FIELD INSPECTION REPORT

Project Name:	Mountain Valley Pipeline	Inspector: M. Willis	Matthew Grant
Inspection Date:	Monday, March 17, 2025	Project Contact:	Brian Clauto Cory Chalmers
Spread G: Giles	Sta 10820-10860 GI 241.03	Weather:	Dry

FIELD INSPECTION PHOTO LOG

Figure 3: STA 10843, re stabilization is required on denuded areas.

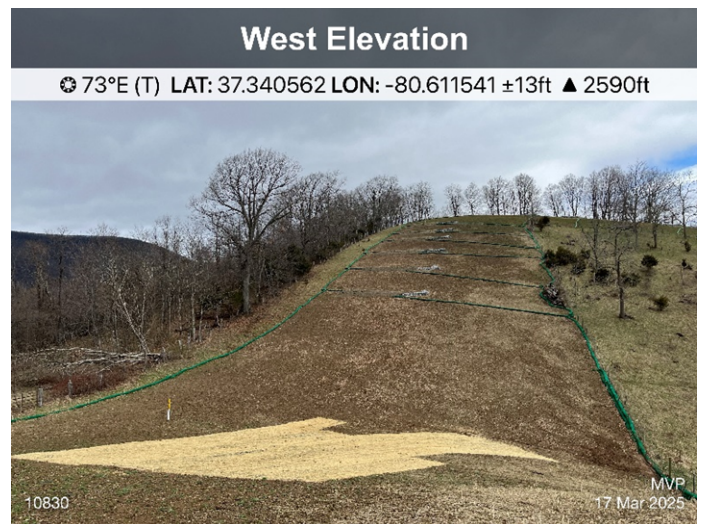
- STA10820-10826, requires re stabilization.
- STA 10830-10831 requires re stabilization.
- STA10840-10846 requires re stabilization and rill erosion repair.
- STA 10850 permanent waterbar requires cleanout and re stabilization.

Recommended Corrective Action: Maintain and install all controls per the approved PSS&S.
